SUBJECT: Submits addl info re proposed tubesheet sleeve design per request. Info addresses inspectability, pullout & corrosion potential. Fifty tubesheet sleeves will be installed during present refueling outage, per 830420 ltr.

April 26, 1983

Subject: Steam Generator Sleaving
R. E. Ginna Nuclear Power Plant
Docket No. 50-244

TUBESHEET SLEEVE

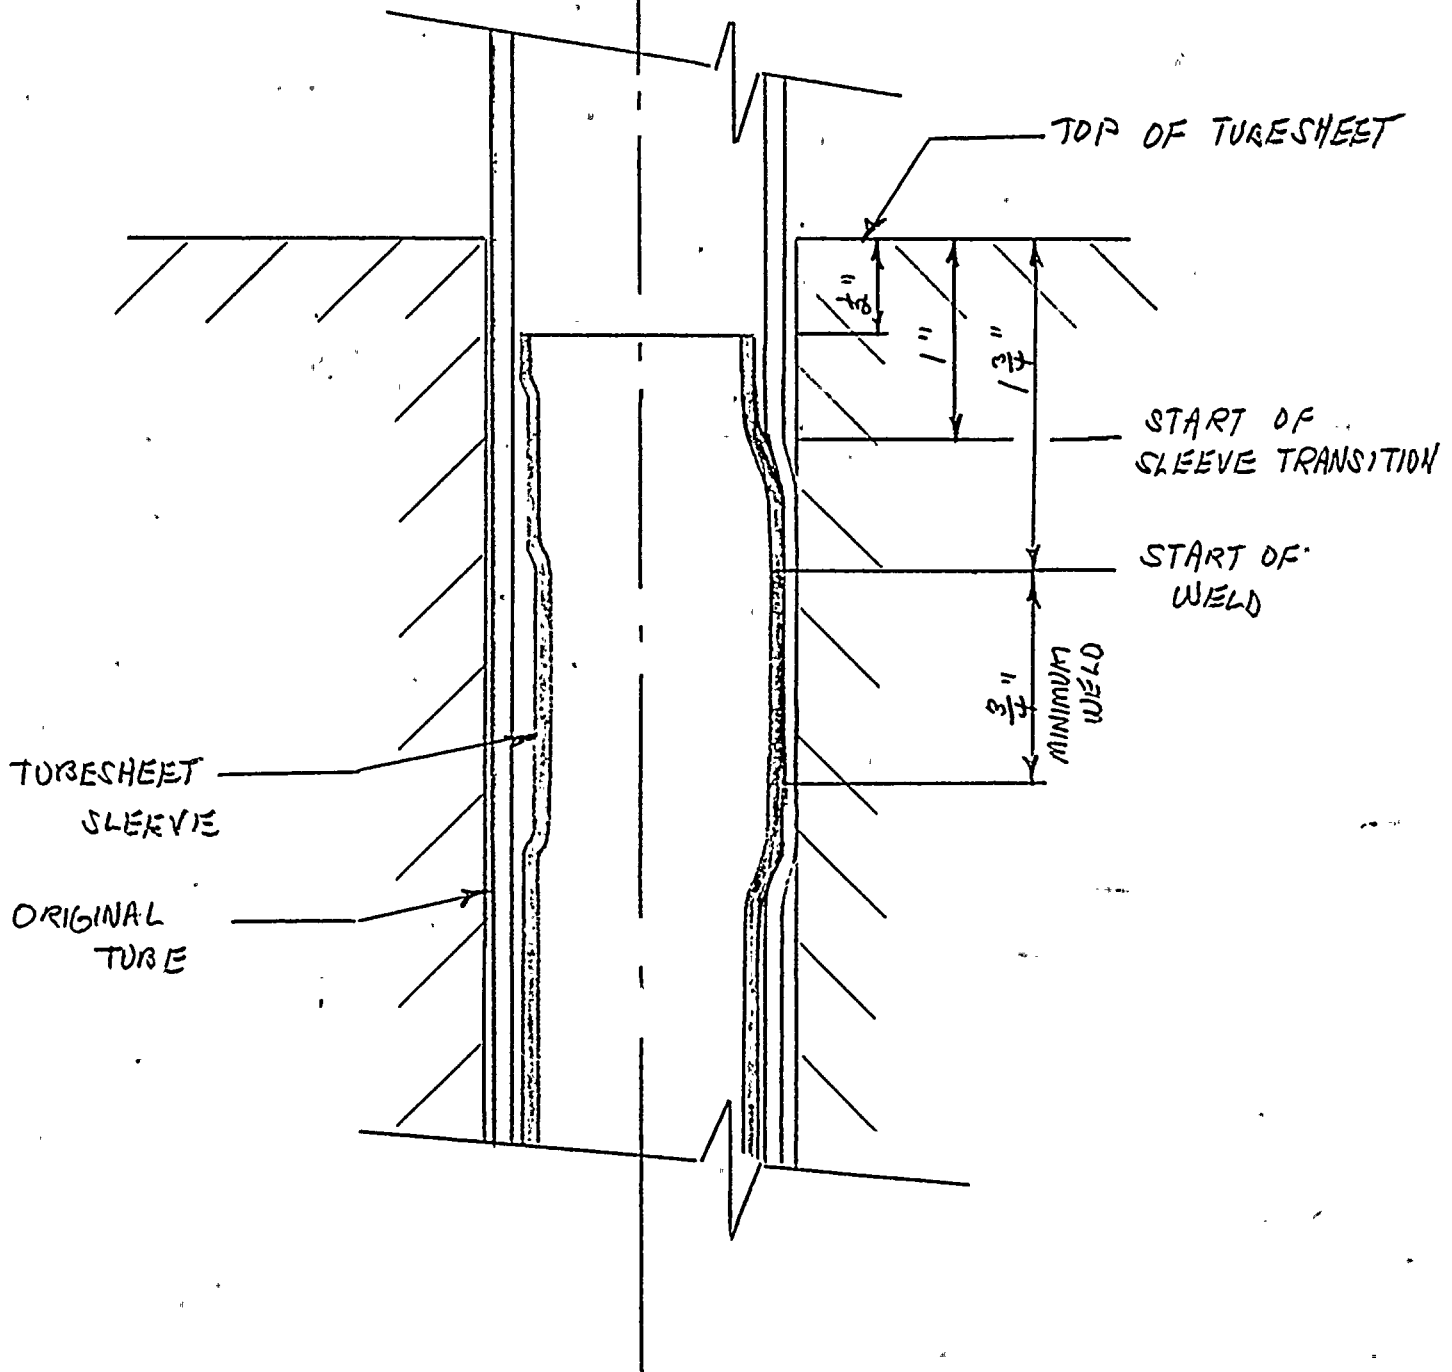
1. Inspectability - The upper expansion transition in the existing steam generator tube resulting from the upper tubesheet sleeve explosive weld can be inspected using our standard eddy current equipment and techniques. By using lower frequencies we can detect flaws in this transition comparable in size to what we can currently detect in the existing tube roll transition. Exact sizing of these indications will be somewhat more difficult due to the lower frequencies required. However, if flaws are detected in this area, additional inspections will be performed using more sensitive techniques such as the rotating, radial differential probe method developed for inspection of the braze/expansion area of brazed sleeves. This equipment is described in our March 25, 1983 letter. The attached drawing shows details of the area to be inspected. The geometry is very similar to that in the braze/expansion area.

2. Pullout - The upper expansion transition in the existing steam generator tube resulting from the tubesheet sleeve explosive weld is a minimum of 1 inch below the top of the tubesheet. In Section 6.2.3.3 of our April 26, 1982 Steam Generator Evaluation Report there is an analysis of pullout. That analysis shows a
